IMPROVED RELATIONSHIP TO 137-143 HERRING ROAD

3.0 REVISED SCHEME SUMMARY

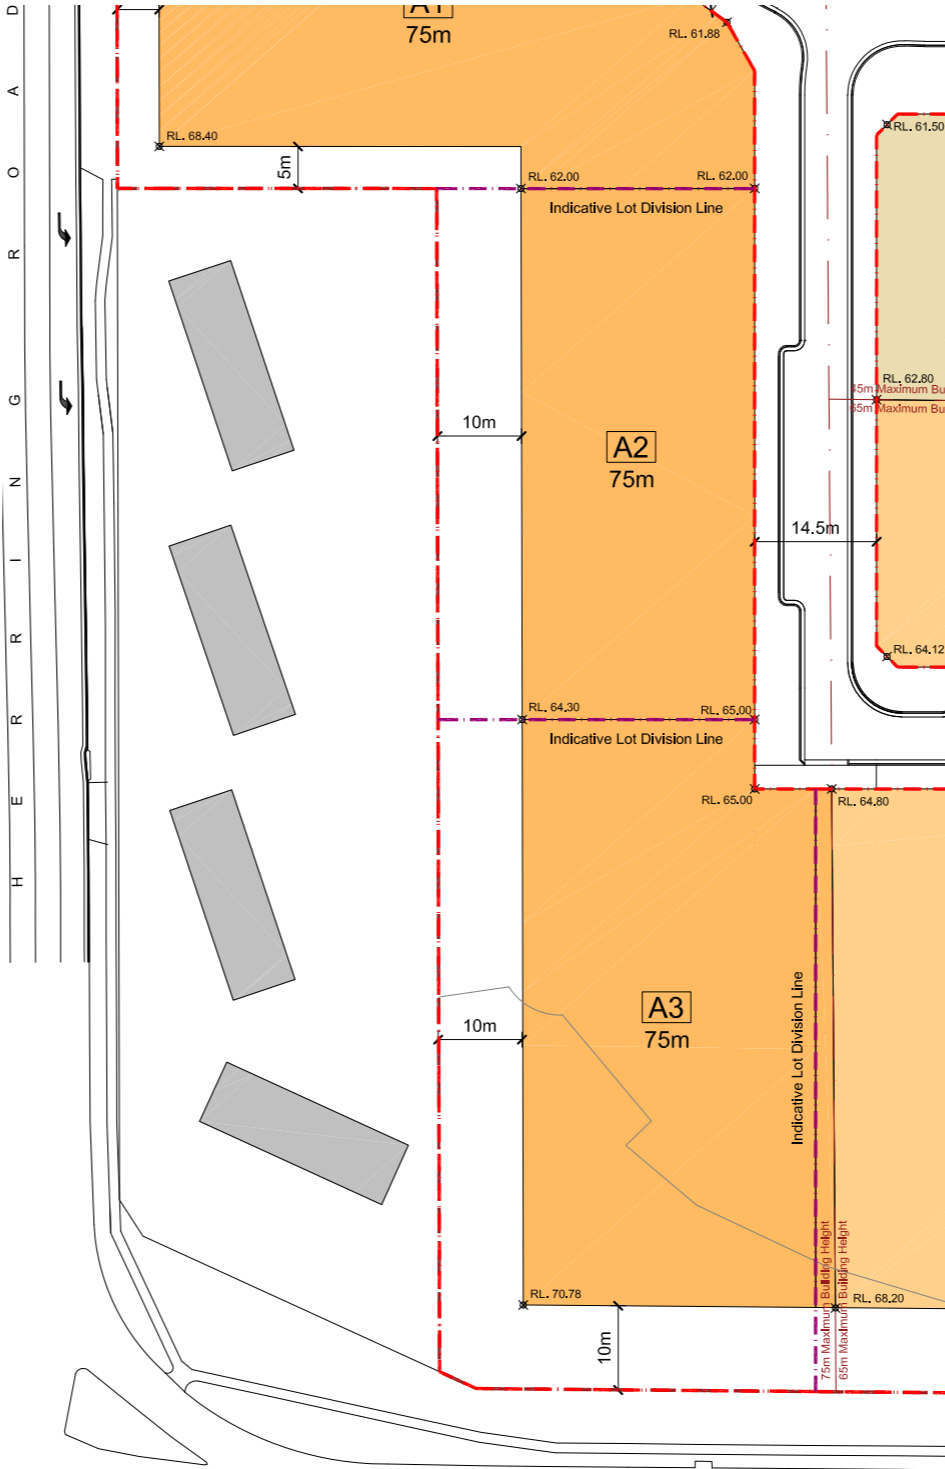
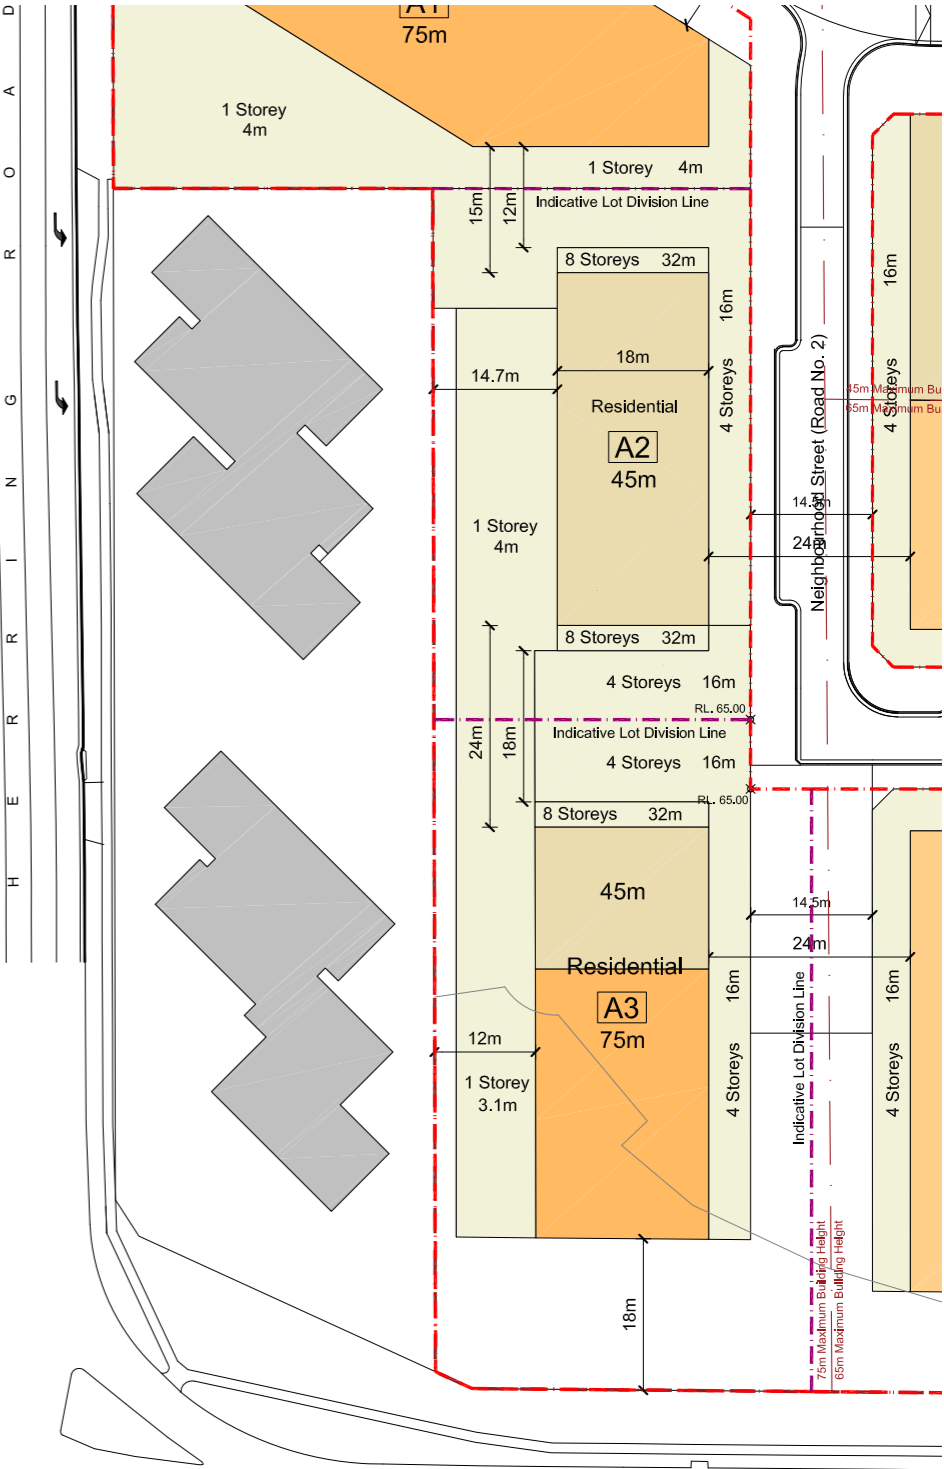
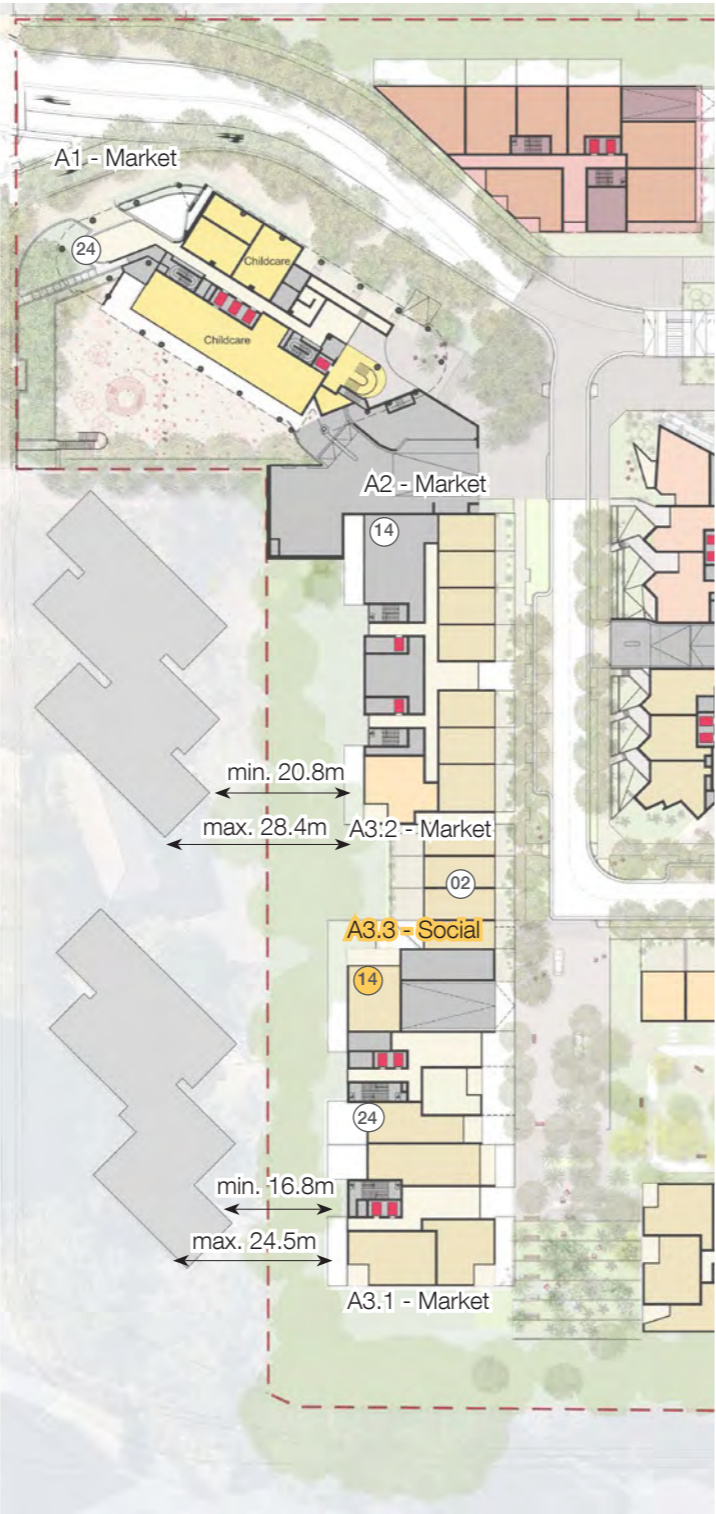
Adjacent to the recently approved 24 storey buildings on the neighbouring sites, the envelopes have been reconsidered to provide:

- / increased building separation
- / improved visual privacy
- / improved solar access throughout the mastepplan

Due to overshadowing from the recently approved proposal, buildings A2 and A3 will not achieve 70% of apartments with more than two hours of sun on the winter solstice. The indicative design scheme has been developed to maximise the amenity of apartments in these buildings. Measures include:

- / Building separation distances greater than required by the ADG
- / Dual core buildings with fewer apartments per core
- / Increased apartment sizes
- / Living rooms directed away from the neighbouring development

IMPROVED SHRIMPTONS CREEK INTERFACE

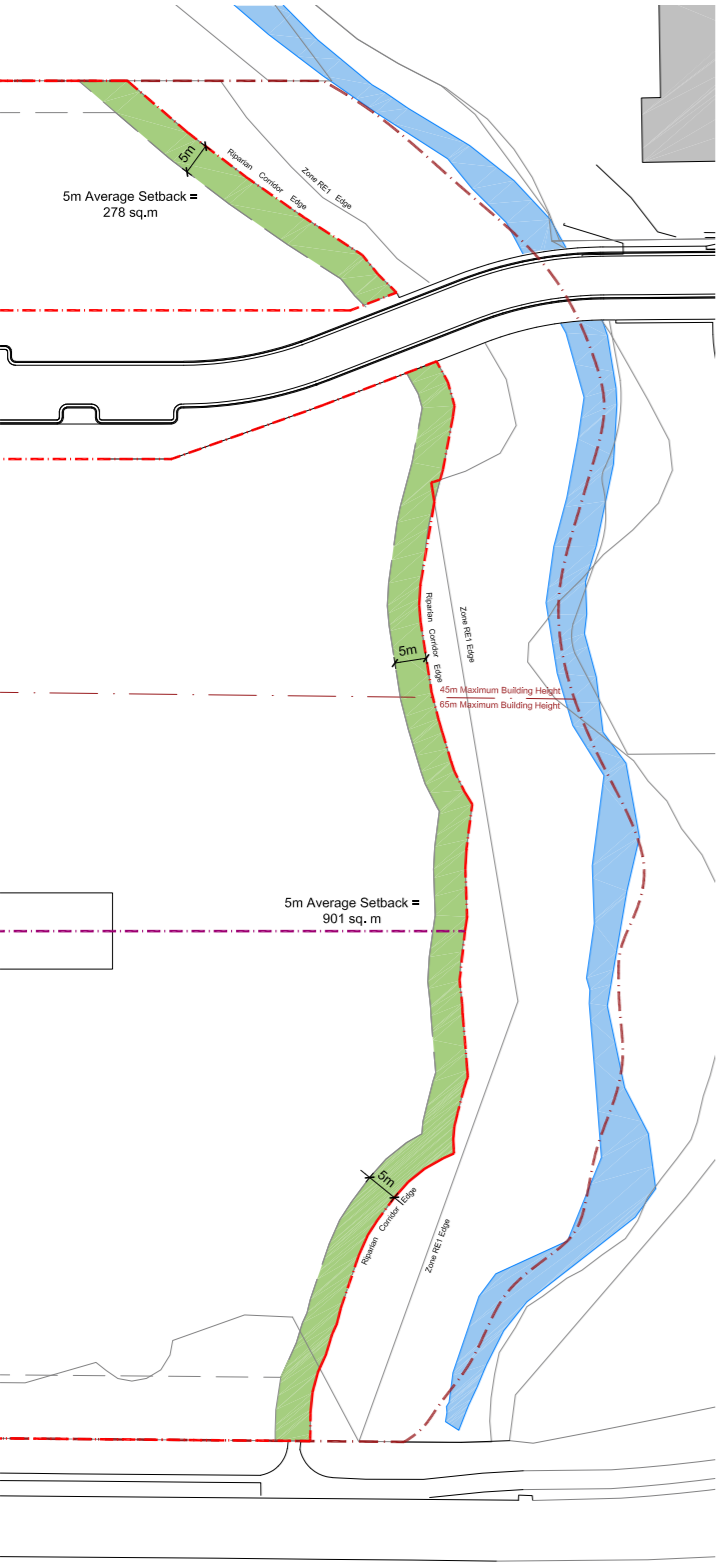
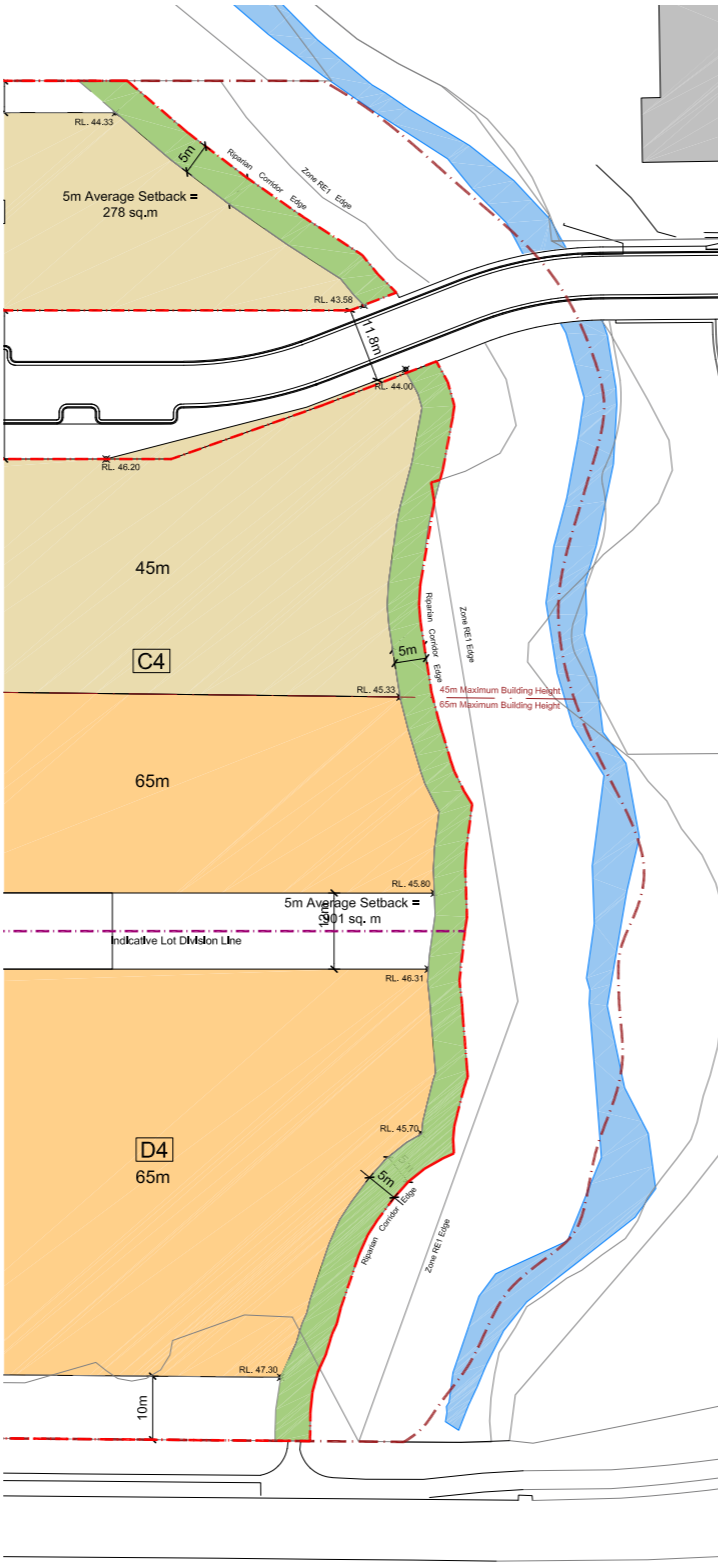
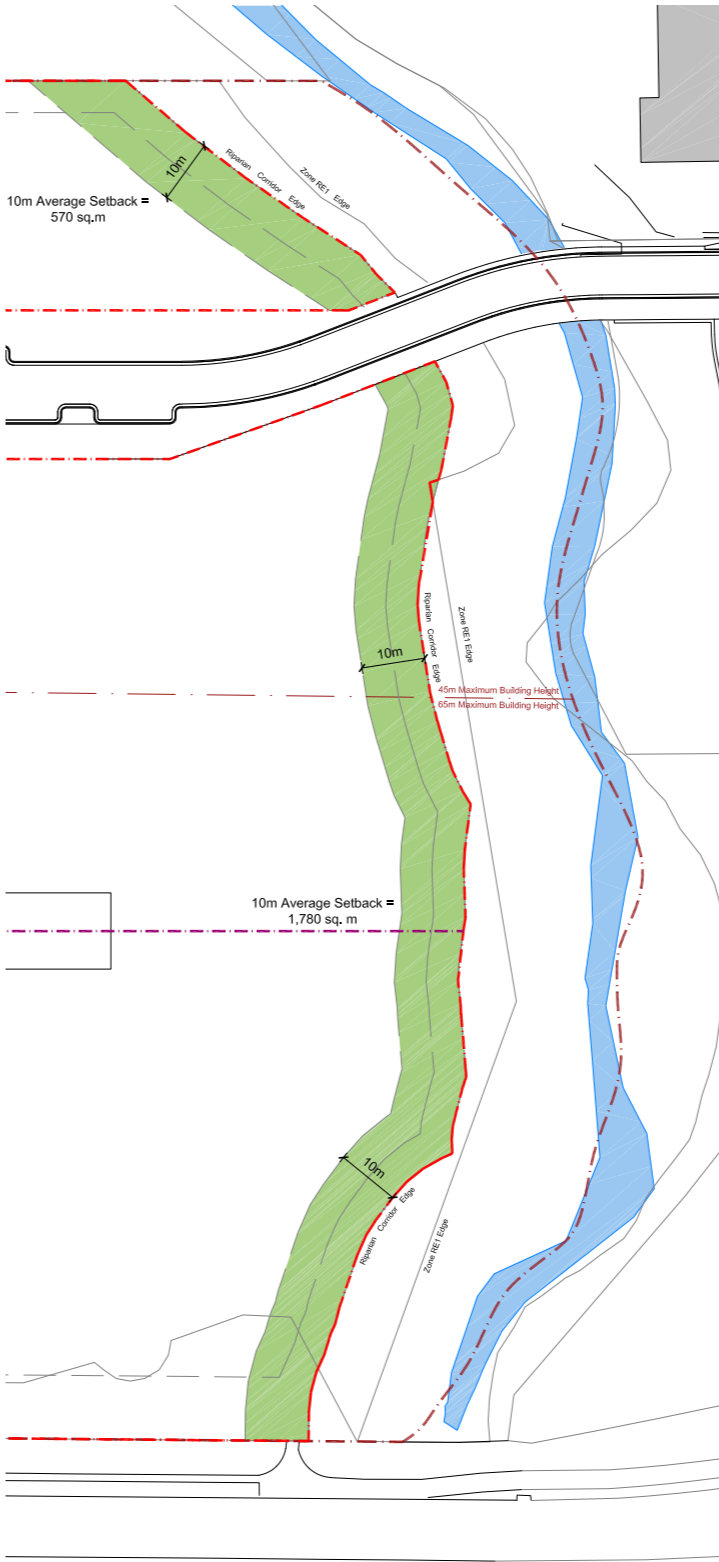
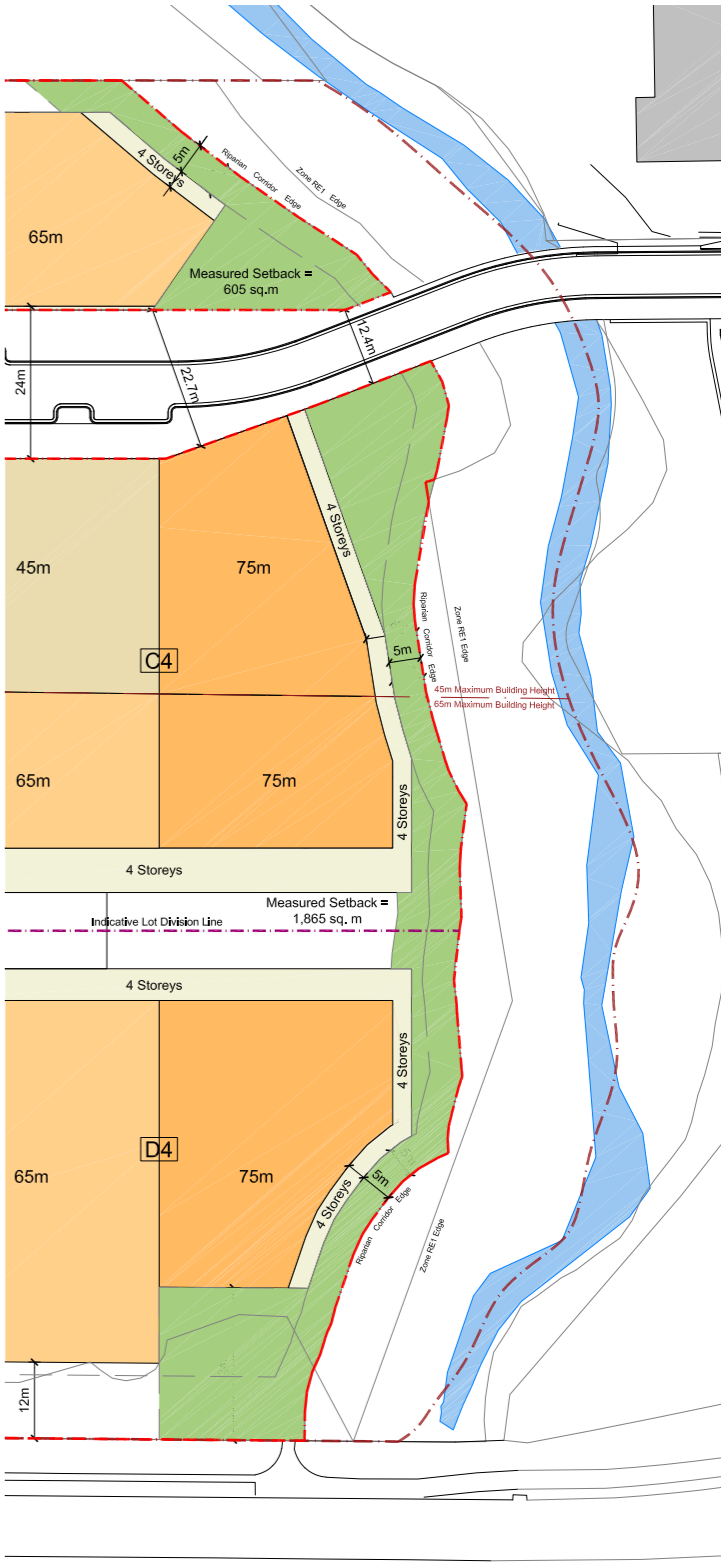
SSDA: RIPARIAN CORRIDOR
A riparian protection zone along Shrimpons Creek accommodates a shared path in a bushland setting. The masterplan proposes to regenerate the corridor and add passive recreational uses.

REVISED - RIPARIAN CORRIDOR
The riparian corridor's width has been increased in key locations. The masterplan proposes to regenerate the corridor and add passive recreational uses.

DCP REQUIREMENT - 5M SETBACK
1,180m²
In accordance with City of Ryde DCP 2014
Macquarie Park Corridor Section 7.4(a)(v)

**10M SETBACK REQUESTED BY RYDE IN
DETAILED SUBMISSION**
2,351m²

PROPOSED SCHEME
2,470m²
Variable width setback no less than 5m. Total
area greater than 10m continuous setback.

TREE RETENTION

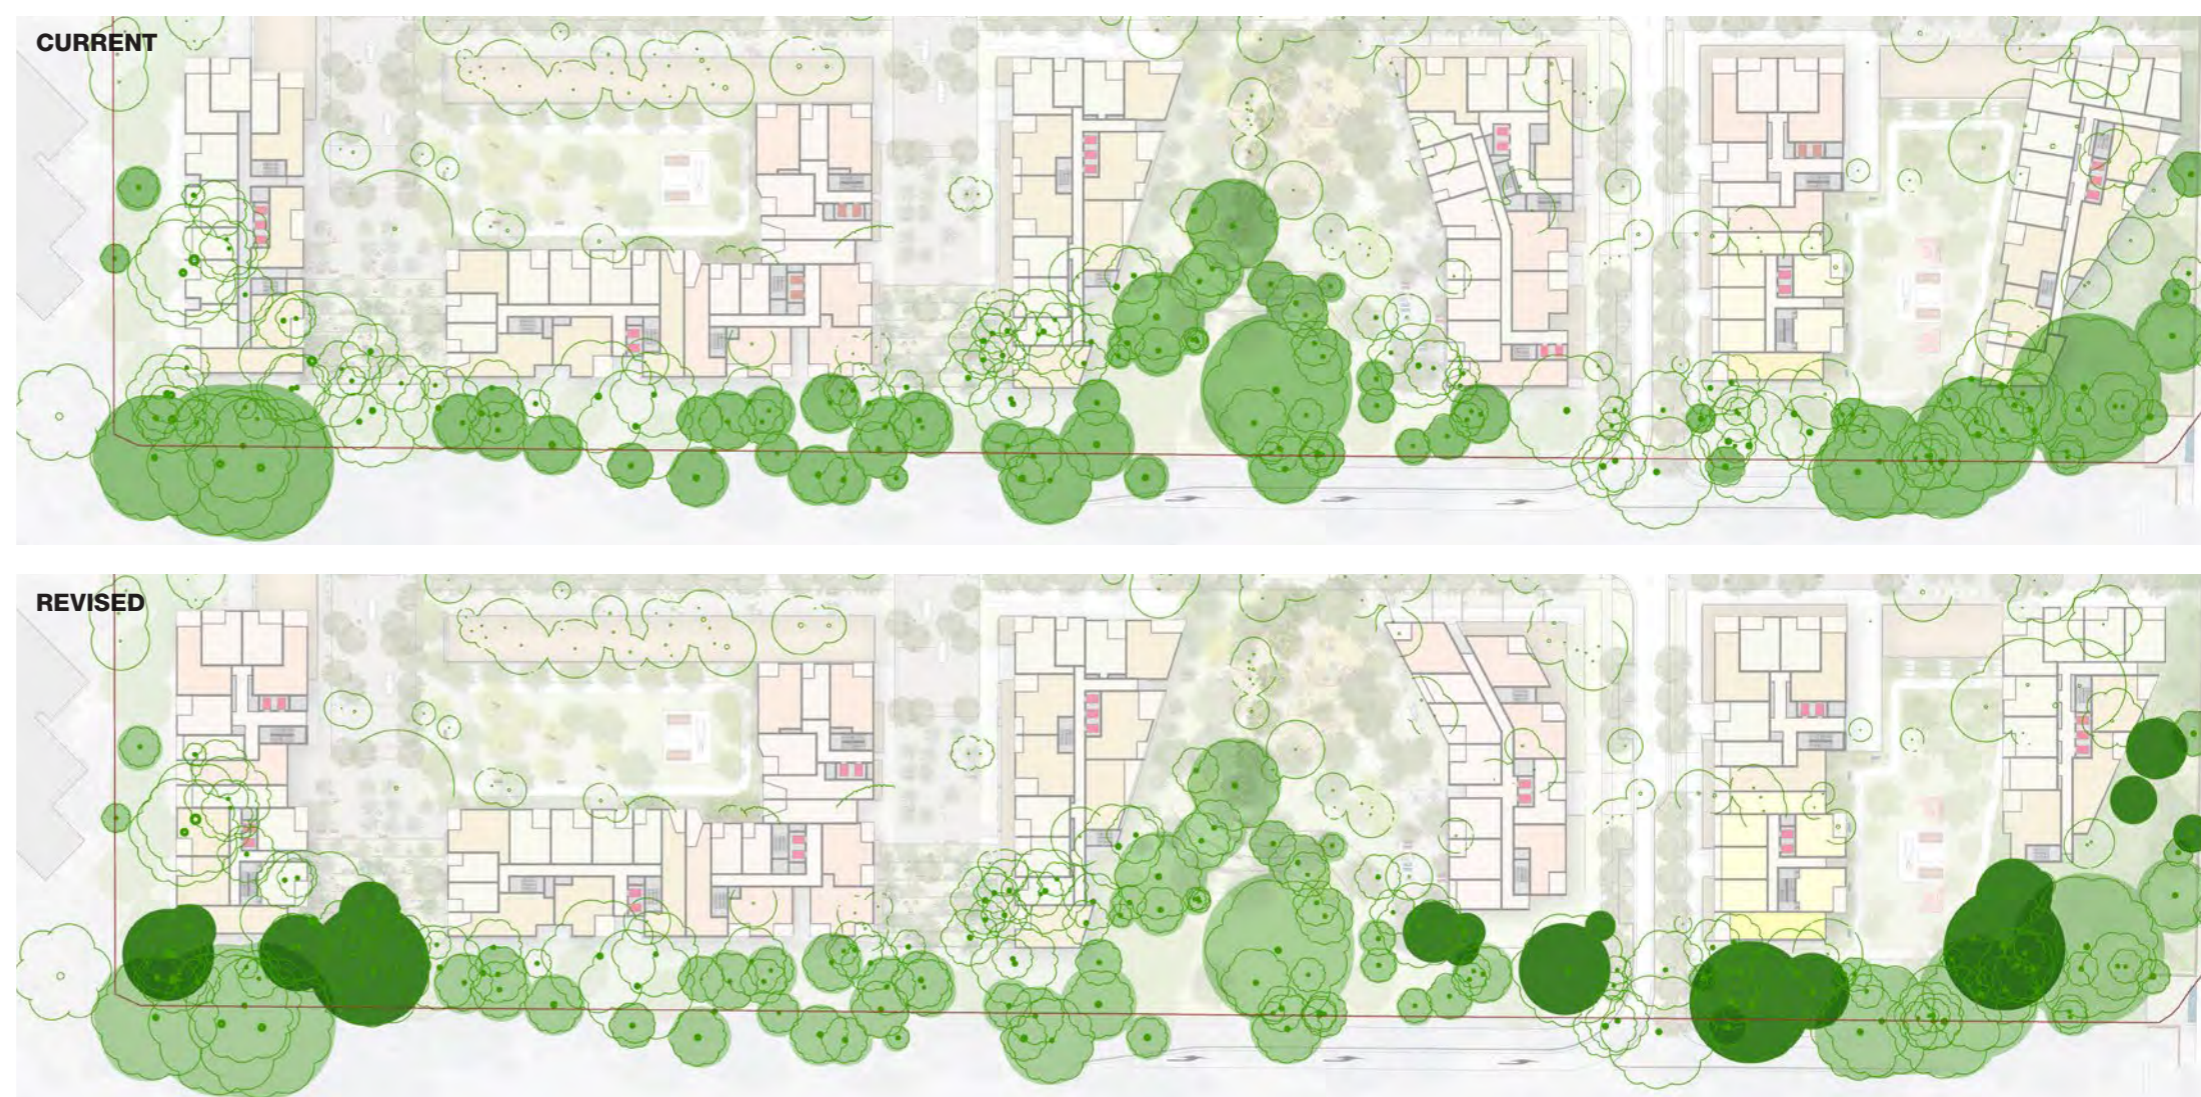
Building envelopes have been refined, set back further from Shrimptons Creek, to ensure that over 100 additional trees can be retained on the site, including alongside the riparian corridor.

SSDA - FOREST THRESHOLDS
Where the shared local streets meet the perimeter bushland, forested urban gardens will formalise these transitions.

REVISED - FOREST THRESHOLDS
An increased setback from Epping Road is provided to protect additional existing trees.

Building envelopes have been refined, set back further from Epping Road, to ensure over 100 additional trees can be retained on the site, including the Epping Road vegetation corridor which includes Sydney Turpentine Ironbark Forest.
